August 1, 2005

Docket No. 50-271  
BVY 05-072  
TAC No. MC0761

Subject: **Vermont Yankee Nuclear Power Station  
Technical Specification Proposed Change No. 263 – Supplement No. 30  
Extended Power Uprate – Response to Request for Additional Information**

**Figure SRXB-A-6-1**  
**Cycle 24 MFLCPR**

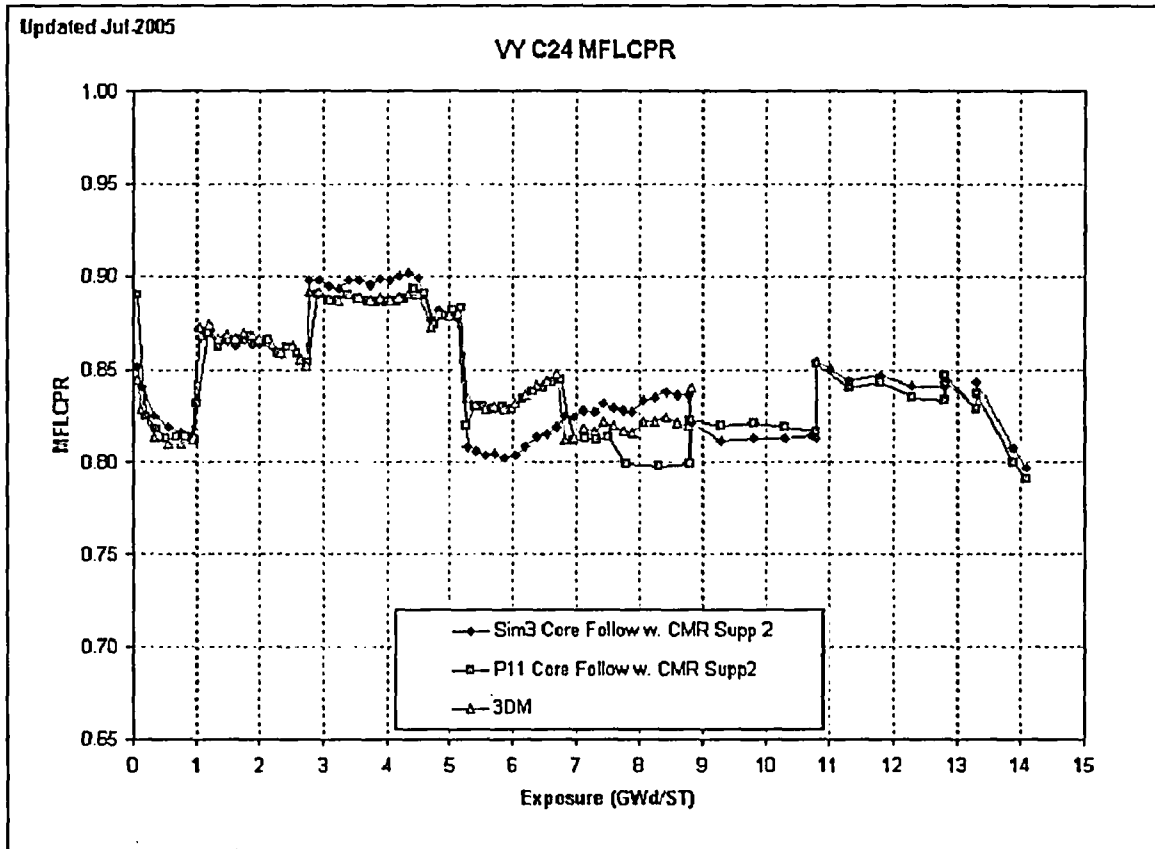
SIMULATE-3 shows good agreement with GNF methods as shown in *Figure SRXB-A-6-1* and there is substantial margin where the codes do not agree. The data points beyond the last 3DM point represent the as designed expected values for each thermal limit, in this case the Cycle 24 (current cycle) Cycle Management Report (CMR), Supplement 2.

**Figure SRXB-A-6-2**  
**Cycle 24 Pin Power Reconstruction Based MFLPD**

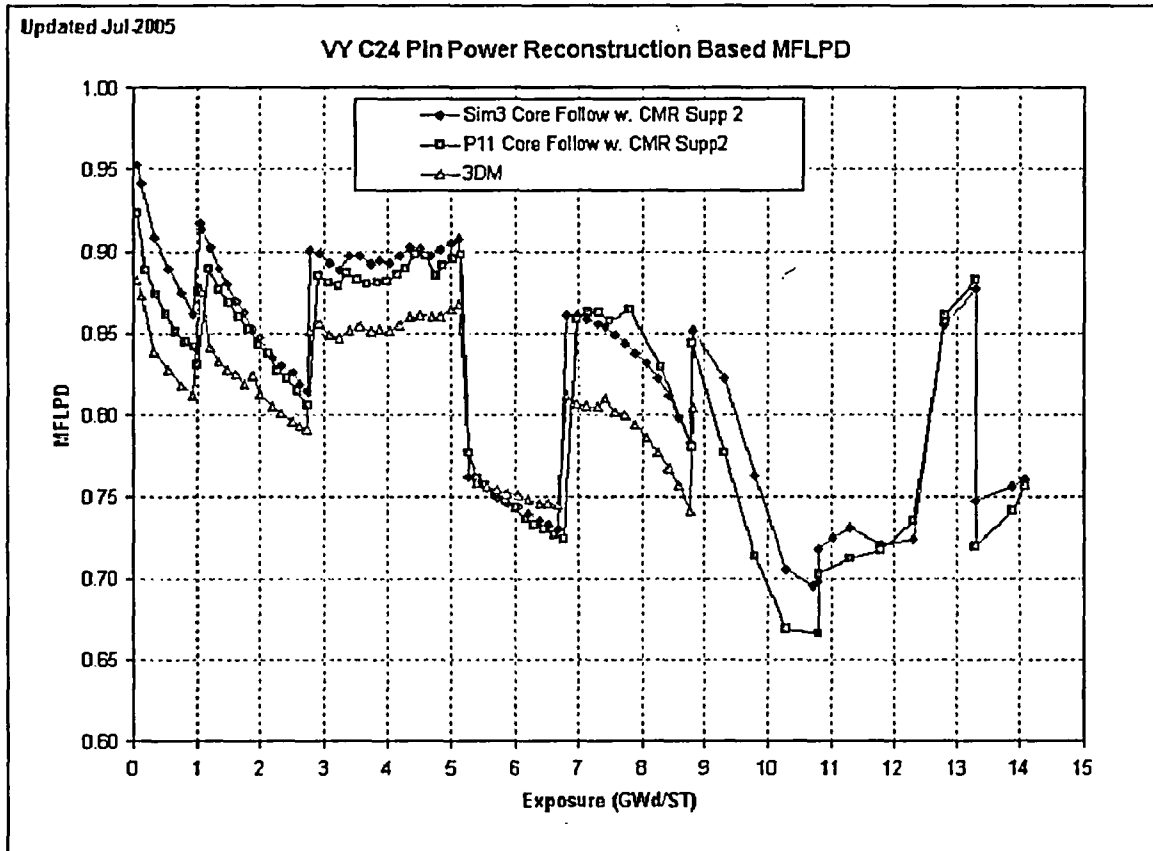
SIMULATE-3 uses its own pin power reconstruction module to determine MFLPD. As in *Figure SRXB-A-6-2*, in most cases, SIMULATE-3 and P11 calculate a larger and more conservative MFLPD than is representative in actual 3DM online operations, but the two offline codes agree relatively well.

Figure SRXB-A-6-3 – Cycle 24 MAPRAT

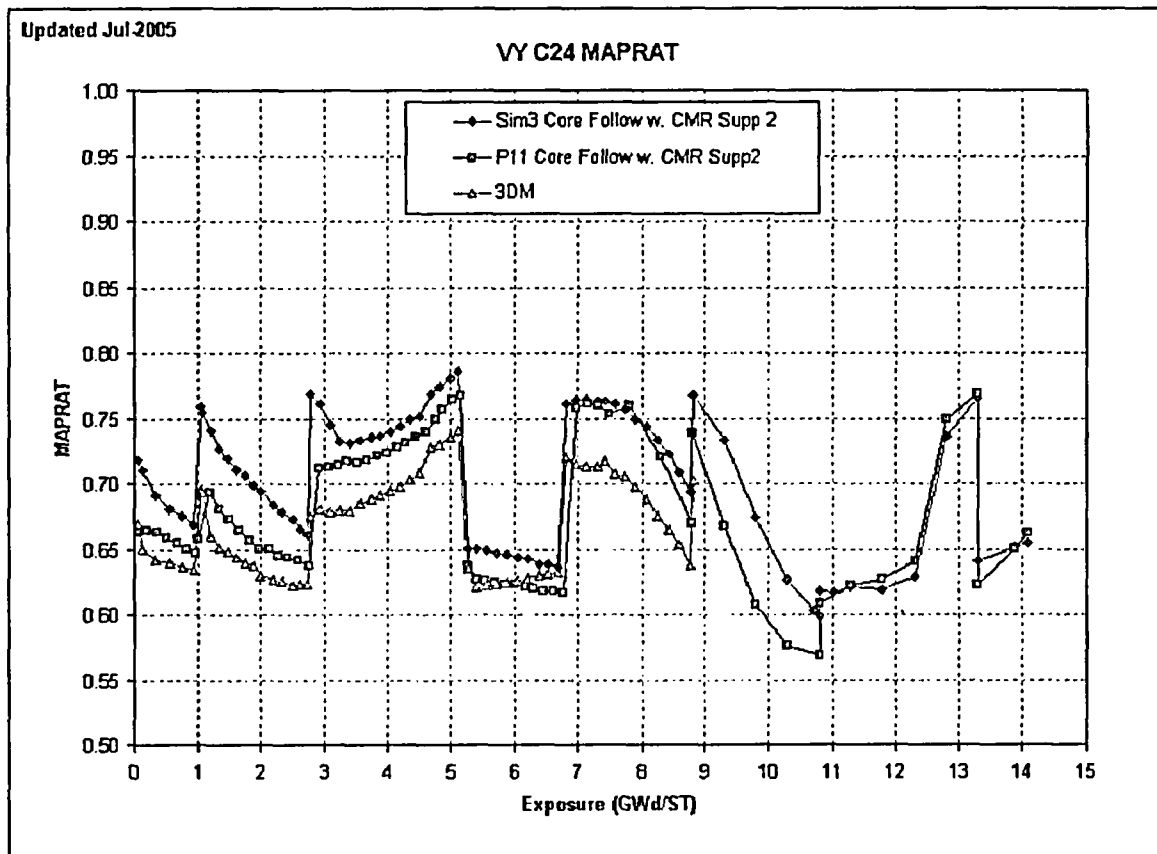
MAPLHGR is a nodal parameter and requires no additional SIMULATE-3 module for its calculation. SIMULATE-3 and P11 have a fairly consistent bias over 3DM as shown in *Figure SRXB-A-6-3*. MAPRAT is typically the least limiting thermal limit at VYNPS.

Figure SRXB-A-6-4  
Cycle 24 TIP Comparison Data

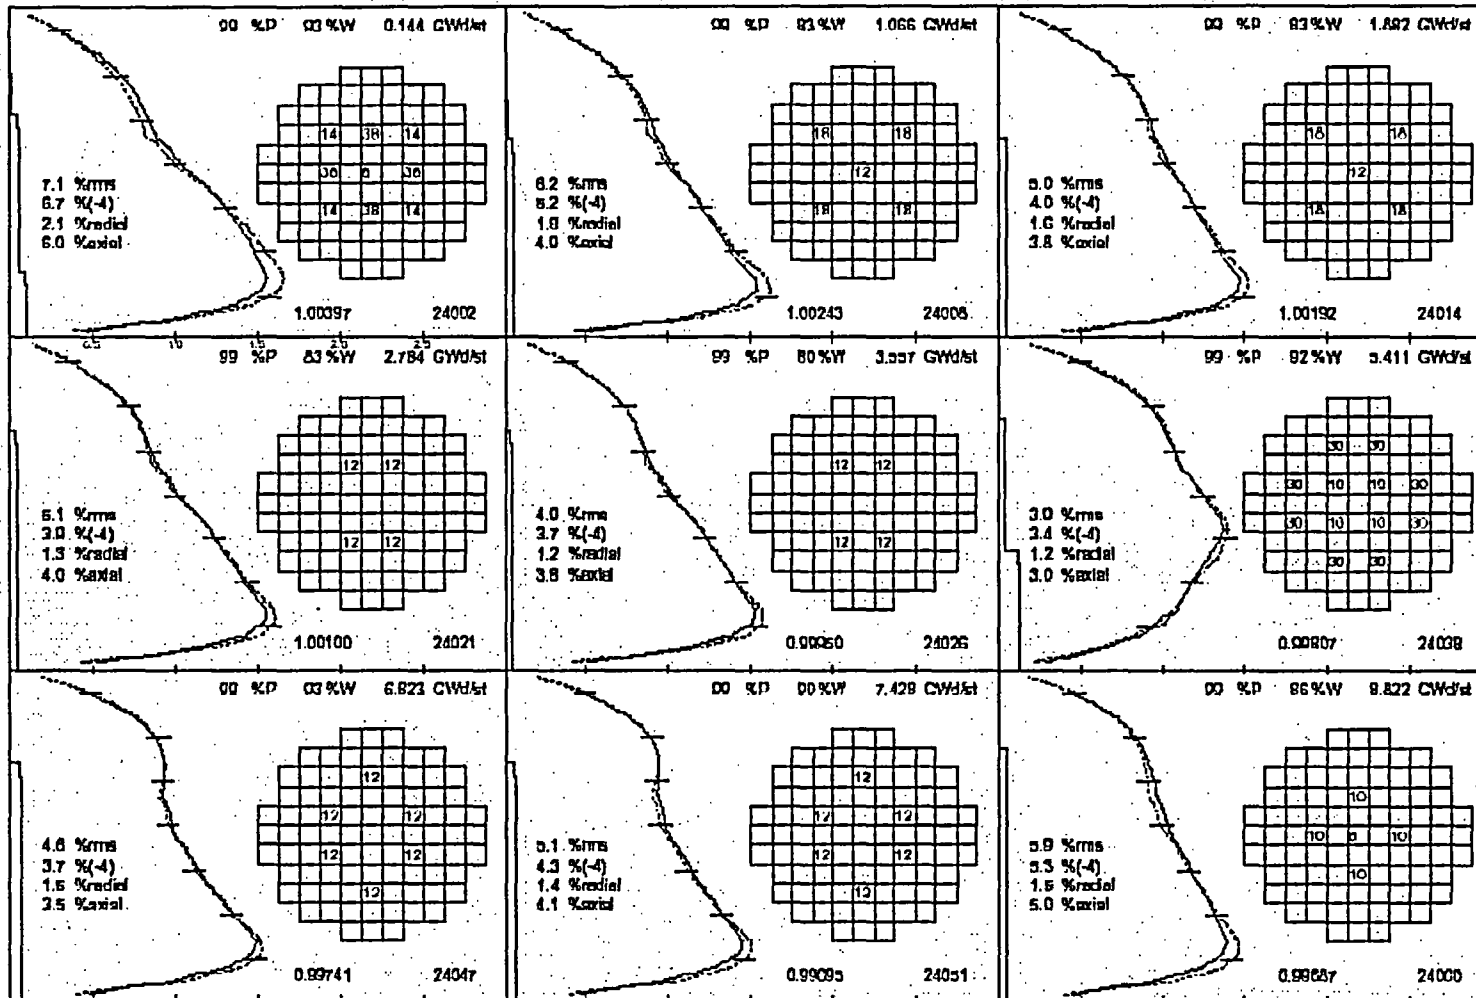
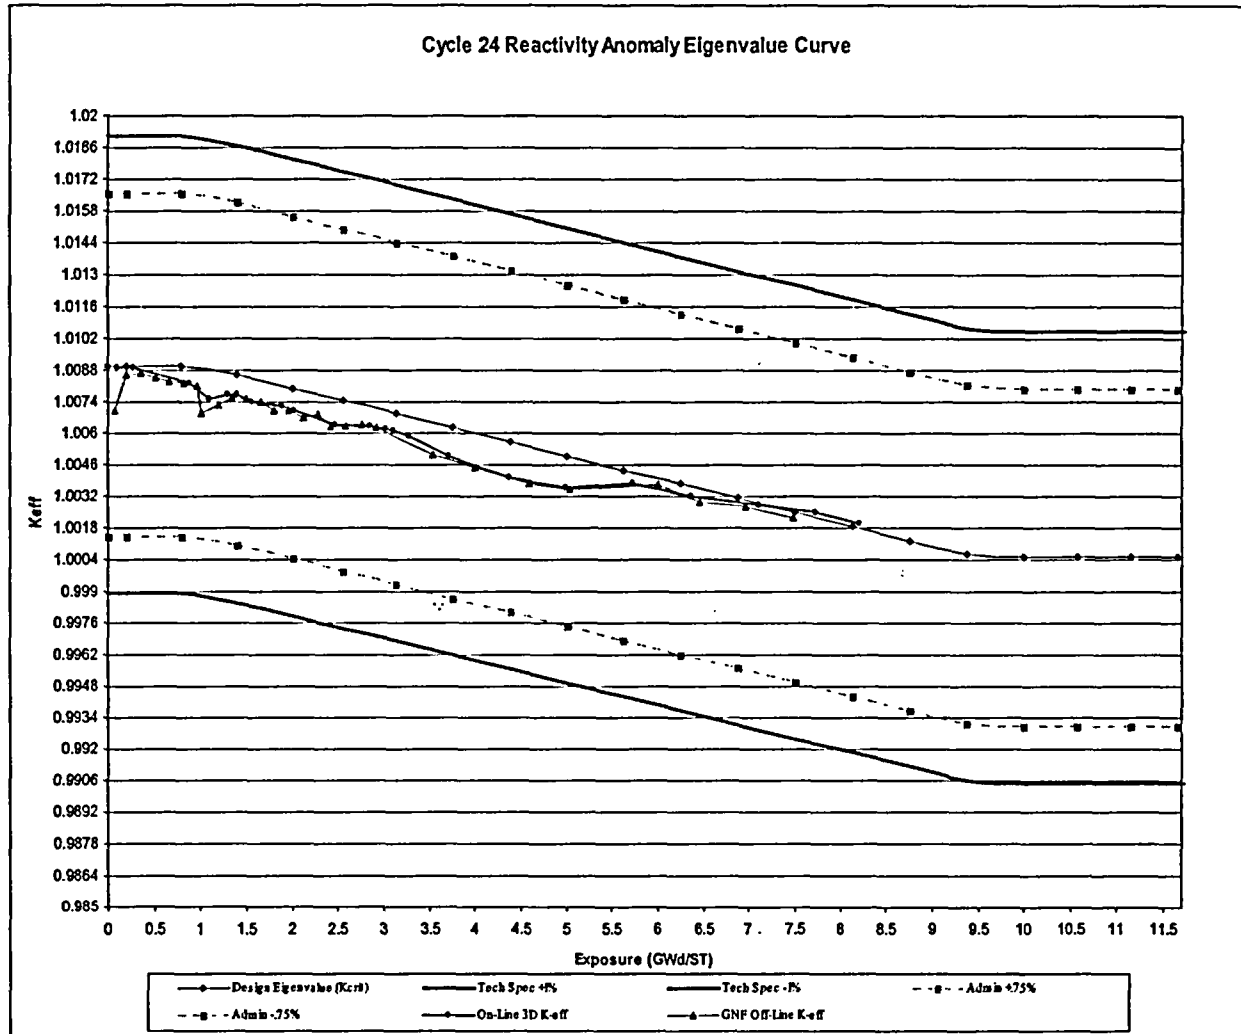
The following TIP output, *Figure SRXB-A-6-4*, depicts the comparison for VYNPS Cycle 24. The dashed line represents SIMULATE-3 and the solid line, 3DM. The radial, axial, and nodal RMS error values are calculated for each combined core average TIP. Any larger than expected

deviations are reviewed with plant reactor engineers, nuclear engineering analysis (NEA) engineers, and the NEA manager, per the core follow procedure, to investigate the discrepancy and, if necessary, take action. The low RMS errors provide a high confidence that the VYNPS SIMULATE-3 model is correctly calculating the power distribution.

Figure EMEB-B-142-1:  $a_n$  coefficient for 32Hz

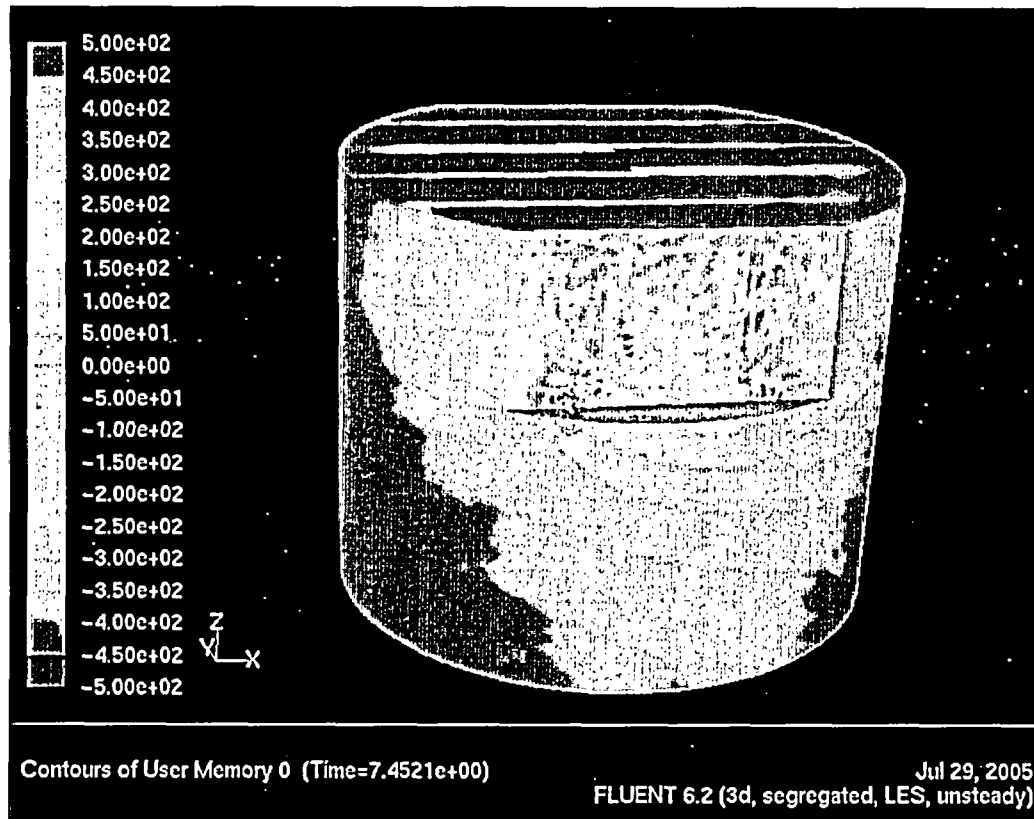
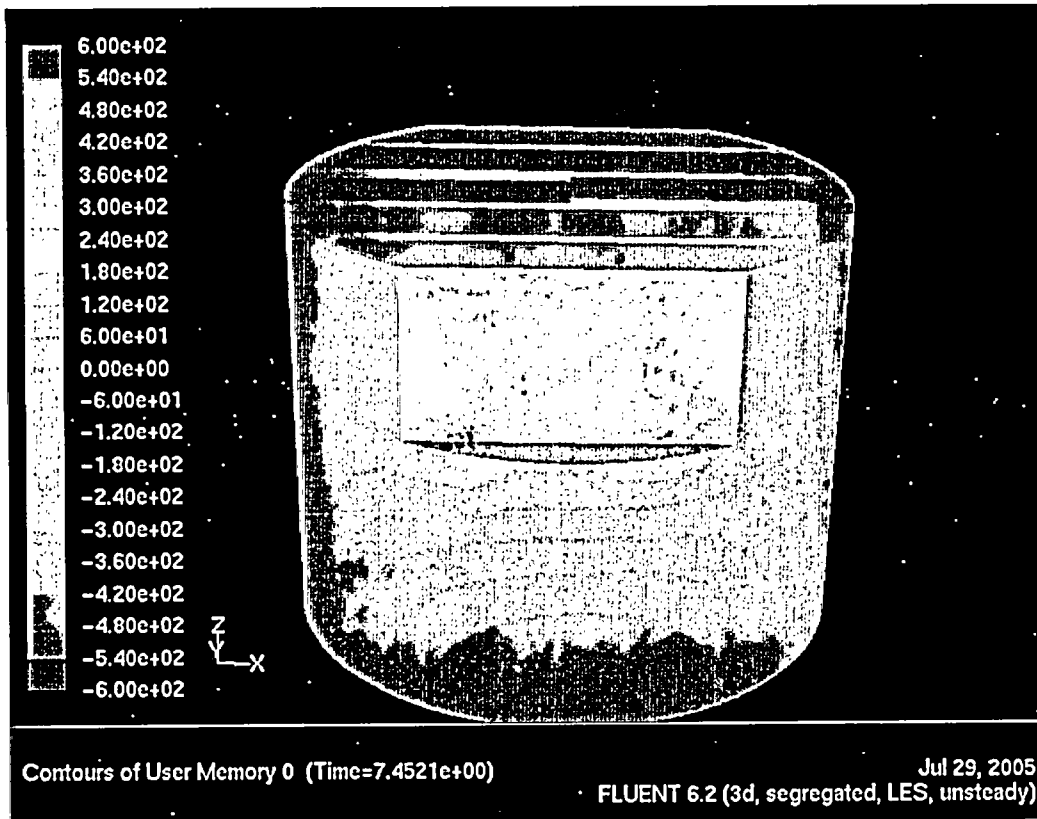
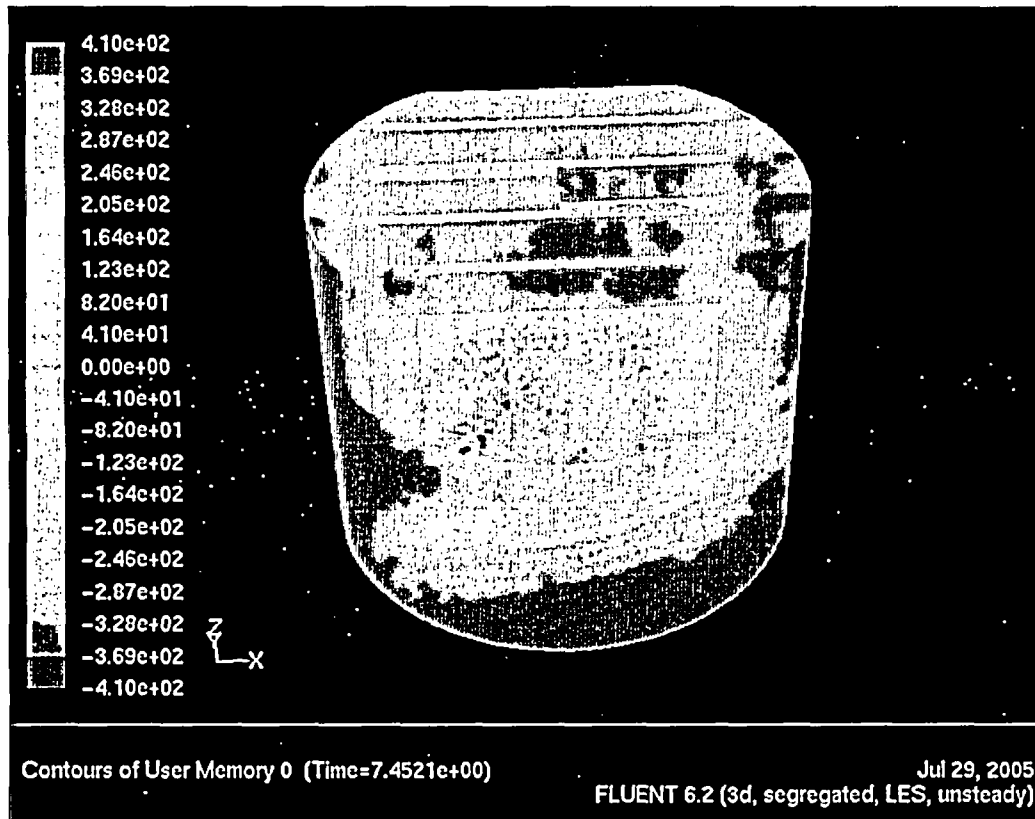
Accurate predictions of the propagation of pressure waves can be obtained if the time step is chosen such the Courant number based on the speed of sound is close to unity. The time step chosen was based on the fluid flow velocity rather than the speed of sound and is about 10 times larger than required for tracking sound waves. With a large time step pressure waves are propagating at the speed of sound. However, a sharp pressure front could be diffused and

attenuated with distance from its origin. The large time step relative to acoustic phenomena could have a damping effect on any acoustic signal.
